UNITED STATES PATENT AND TRADEMARK OFFICE

10/749,621

Office Action Summary

DETAILED ACTION

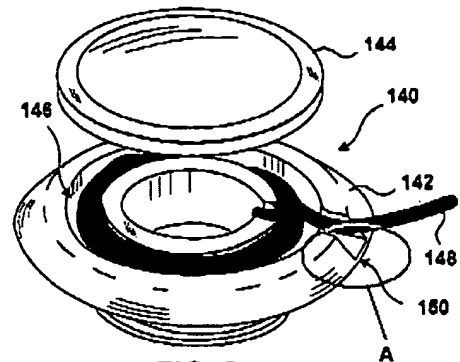
1. Claims 12, 15, 20-23, 36-41 are rejected under 35 U.S.C. 102(e) as being anticipated by Singhal et al. (US Patent Publication 20050004637 A1). Singhal et al. discloses a burr hole cap with a lead management system as depicted in figure 8.

As to claim 12, the ring member 142 is considered to be a flange. The examiner considers the walls of groove or exit 150 to be tabs. As depicted in the replica of figure 8 to the right, the wall label "A" is one of the tabs. The two tabs, or walls create the exit 150. Furthermore, the examiner also considers the inner core of the burr hole cap to also possess tabs, with similar groove/tab structure as stated above.

As to claims 12 and 22-23, Additionally there is a plurality of grooves, the inside groove 146 and exit 150, which the examiner considers to be a groove. Also, the cut out in the core of the burr hole cap, where the lead enters the cap is also considered to be a groove.

As to claim 15, since the groove extends from the core of the burr hole ring to the external ring member, the examiner considers the groove to be a "spiral groove" since the groove "extends for the aperture to at least one outlet periphery of the outside surface of the burr ring".
